56th Ballard

Design Recommendation Packet

5601 20th Ave NW, Seattle, WA 98107
SDCI Number: 3035420-LU
December 7, 2020

RESPONSE TO CURRENT EDG (RECOMMENDATION ISSUED JUNE 23, 2020)

Updated Live Work Entries

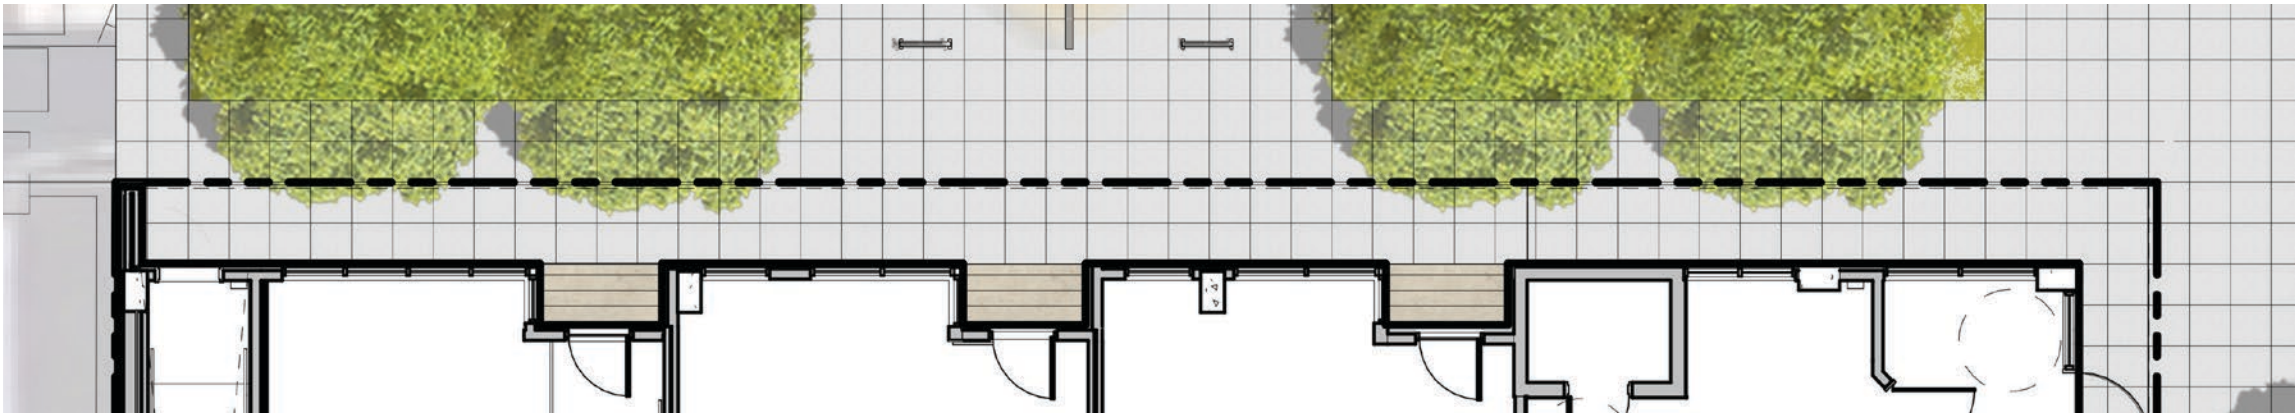
- b. The street level along 20th Avenue NW is largely composed of live/work units with no direct access to the street. The Ballard neighborhood-specific design guidelines specifically discourage live/work uses along Pedestrian streets as they do not typically provide the level of porosity and activation needed. Staff recommends replacing the live/work units with commercial space. If live/work units are pursued, provide street-facing individual entries for all live/work units and further develop the streetscape to provide a dynamic and well activated experience. The pairing of street edge and recessed glazing as currently proposed provides a solid foundation for successful integration of individual entries. Remove the planters placed in front of the recessed glazing to create recessed entries that will help reduce the perceived length of this façade and provide opportunities for pedestrians to step out of the flow of traffic. (PL3-C, PL3-3, PL3-4, DC2-3-a)

- c. The live/work units as currently proposed appear to be designed primarily as residential units. The proposal needs to provide more meaningful opportunities for commercial activity along this Pedestrian corridor and prepare for changing needs as the neighborhood continues to develop. Design the live/work units to be more commercial in function and appearance and utilize non-structural demising walls between units so that the ground level can evolve over time. (PL3-C, DC2-E, DC2-4)

Response: To address previous comments, all live work units now have direct access to 20th ave. Planters have been removed at front of windows and at recessed entries. This entire façade at level 1 has been stepped back 4' to allow for sidewalk widening and provide opportunities for pedestrians to step out of the flow of traffic. Large transparent areas of glazing at the live/works will allow visual connection to interior spaces.

Response: The live/works have been redesigned to provide much larger areas of floor to ceiling glass framed with metal storefront glazing to be clearly differentiated from the residential units above the podium. Partitions between the live/works are non-structural and could easily adapt to commercial activities as the neighborhood evolves.

Updated Corner Element

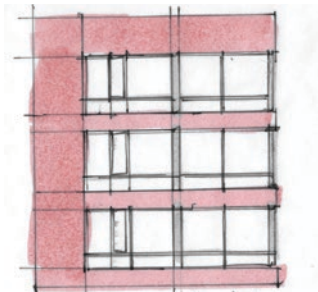
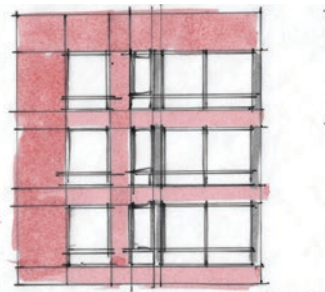
- d. The wood-clad accent piece at the corner adds warmth, creates an interesting focal point, and helps to anchor the corner. However, the potential for this feature is not fully realized as the wood paneling is essentially a frame that wraps an otherwise unchanged portion of the building. This volume needs to be more visually distinct. Increase the depth of modulation and differentiate the glazing to distinguish this volume as an intentional and special place within the larger design concept. (CS2-C-1,CS2-4-a, DC2-2-a)

Response: The wood-clad cube has been made more visually distinctive in these ways:

- A projected 6" steel channel will line the cube and add shade and shadow to the glazed area of the cube
- The cube is now the only area on the building with metal spandrel infill and will read differently from the "tower" above the parking entry and the lighter colored "bookend" on the east façade along 20th.
- The window proportioning of the cube is more horizontal with the addition of a horizontal mullion.
- Alternative #1 shows the wood paneling on the floor spandrels as a study to provide even more horizontality into the cube and is distinct as the glazing treatment only goes from floor to floor instead of being inset with the large "cut out" of the cube.
- Alternative #2 shows an introduction of even more wood paneling into the "cut out" with a 30" wide vertical on the south elevation.

Updated West Facade

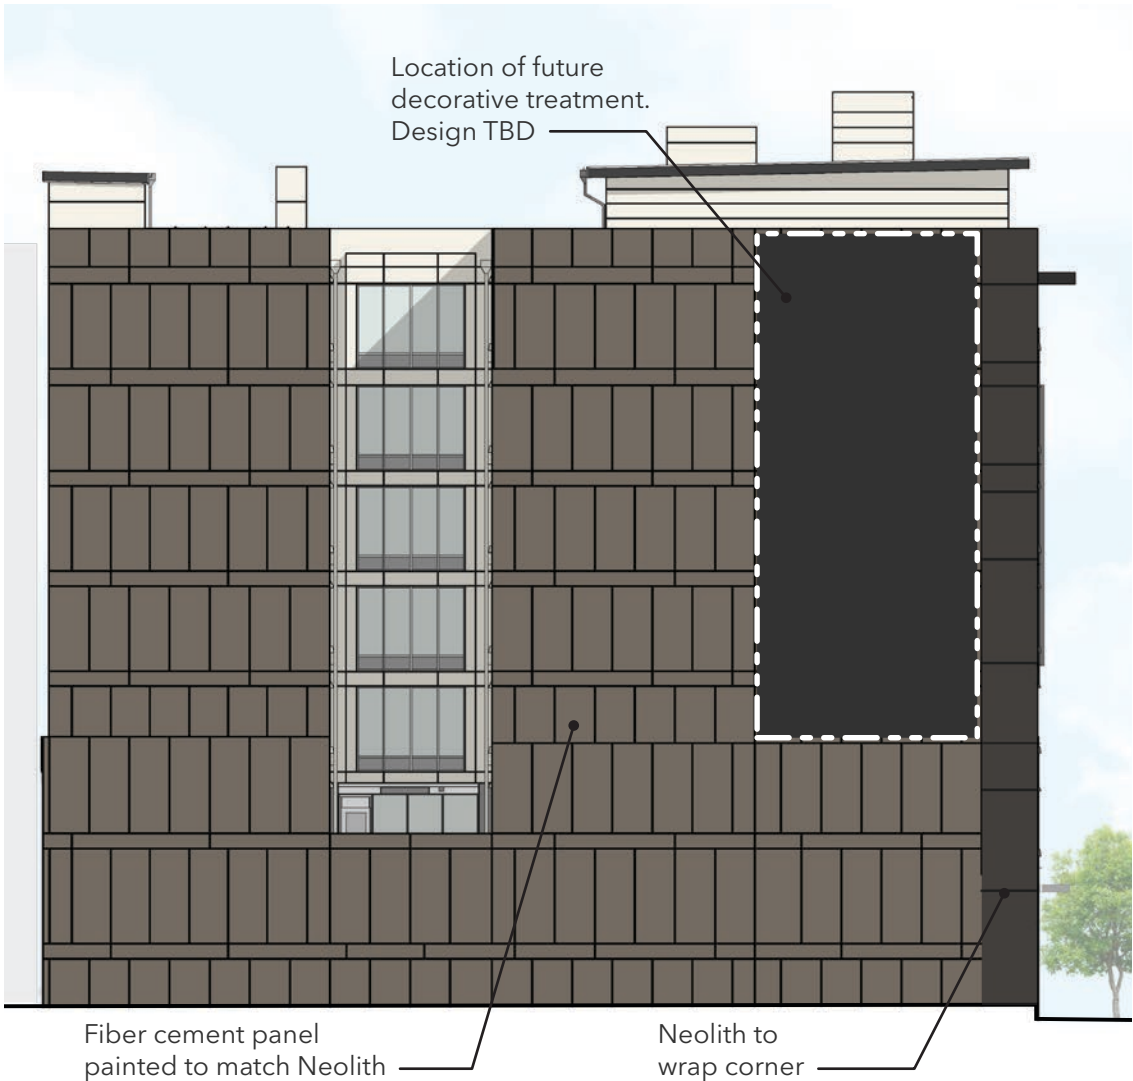
- e. The west façade is largely composed of a blank wall clad in fiber cement panels. Although future development on the adjacent parcel to the west may obscure this blank wall condition, this façade will be highly visible until such development occurs. The elevations indicate that a variety of panel sizes and orientations will be used to add interest and reduce the perceived mass of the structure. Detailing will be essential as will be high quality installation of the fiber cement material. The applicant is encouraged to seek out additional methods of adding interest to this façade, such as through artwork, reveals, or materials. (DC2-B)

Response: At the southern portion of the party wall facade, the stone veneer panel will turn to wrap the corner. A large panel will provide space for a mural by owner and will be visible from the adjacent street up until the time of future development. The remaining areas, flanking the recessed court along the party wall, will be a panels of fiber cement following the same spandrel dimension of the south and east facades and infilled by offset panels for visual interest. The façade will be a dark color to relate to the darker color of the stone veneer wrapping the corner.

DEPARTURE REQUEST ALONG 20TH AVE. NW

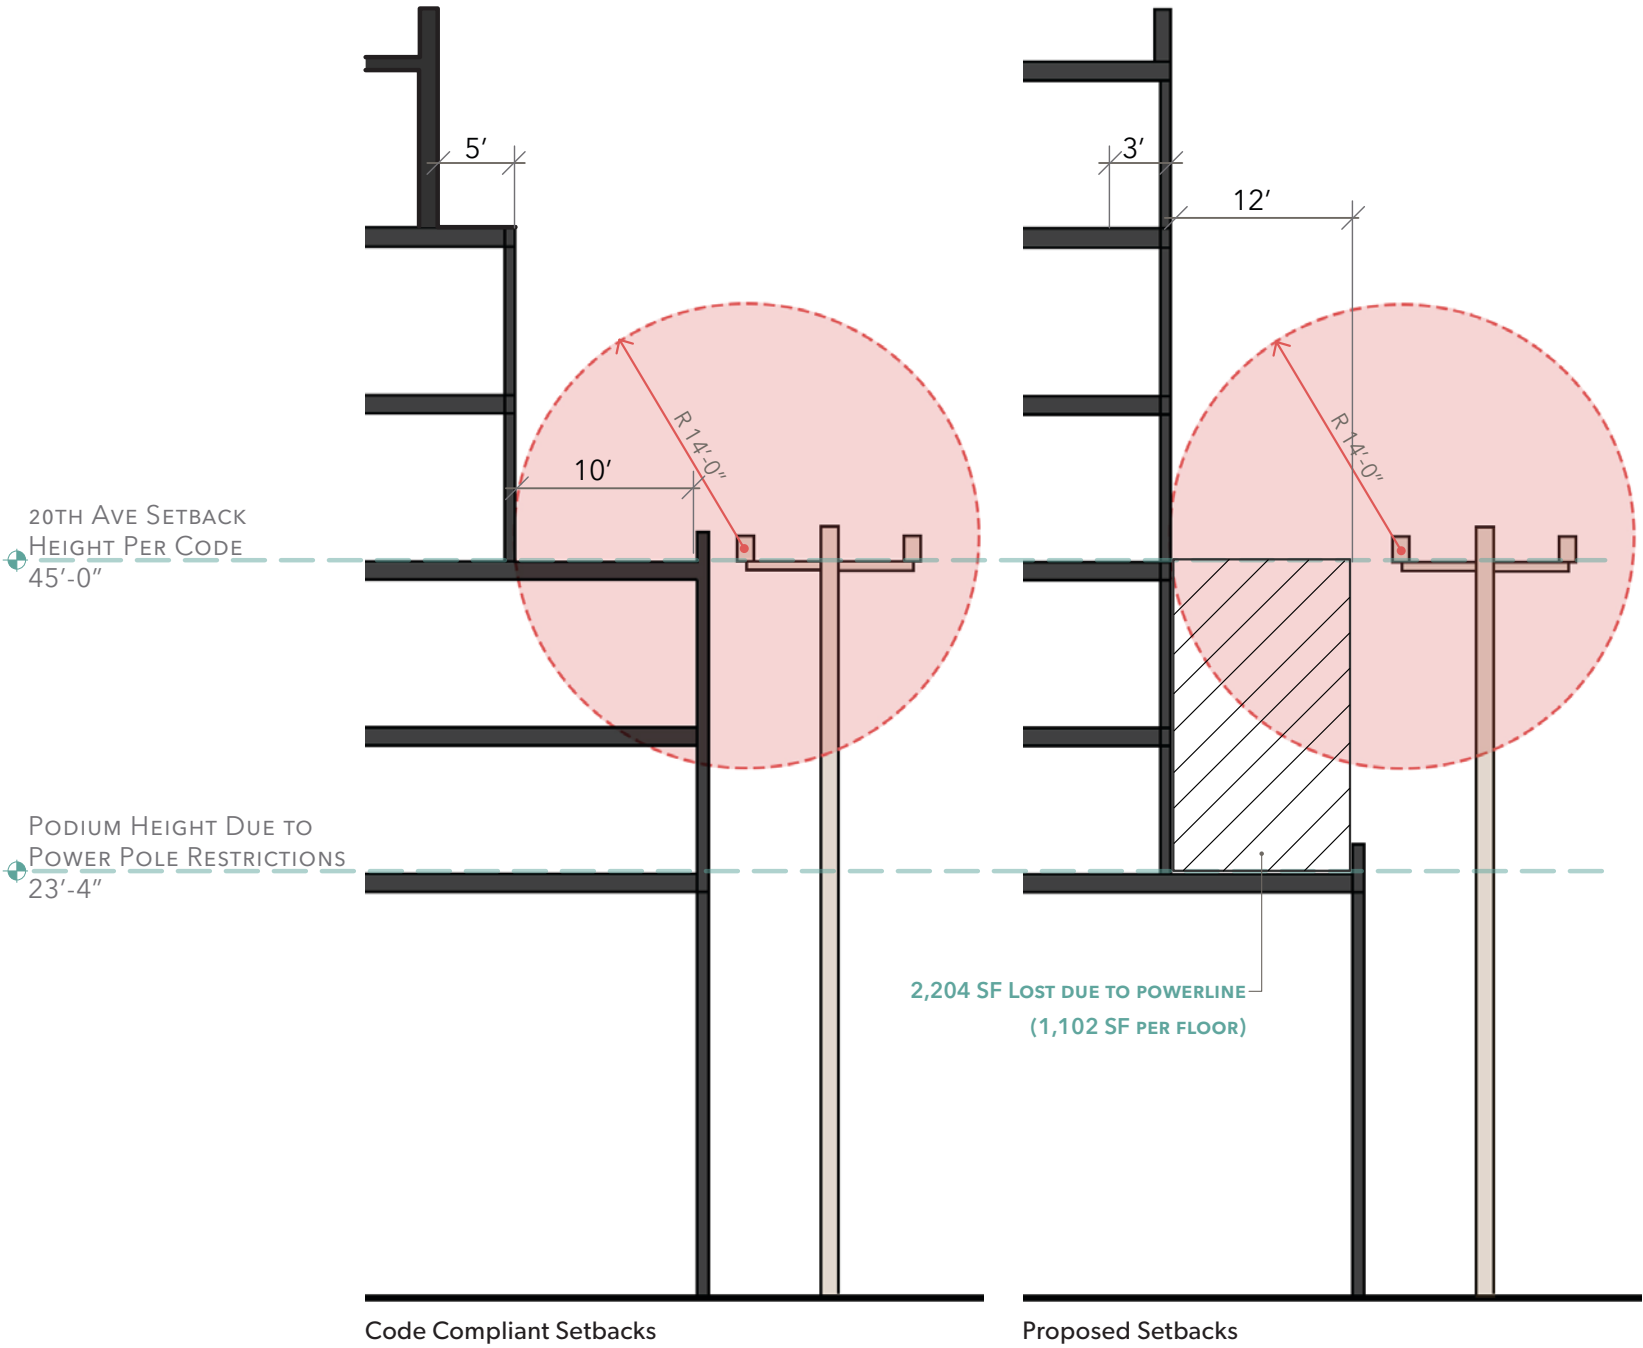
Staff Comments: Staff indicates that the two-story base with upper level setbacks proposed responds well to the existing context and creates a desirable pedestrian scale at ground level. The simple massing of the upper floors is generally supported, though direction has been given to continue refining this volume including some additional modulation. Upon successful integration of this guidance contained in this report, staff is inclined to support the requested departure.

The applicant is seeking to depart the average 15’ depth above 65’ along 20th and is stepping back 12’ deep at +23’ above the street for the entire façade above Level 3 through Level 7.
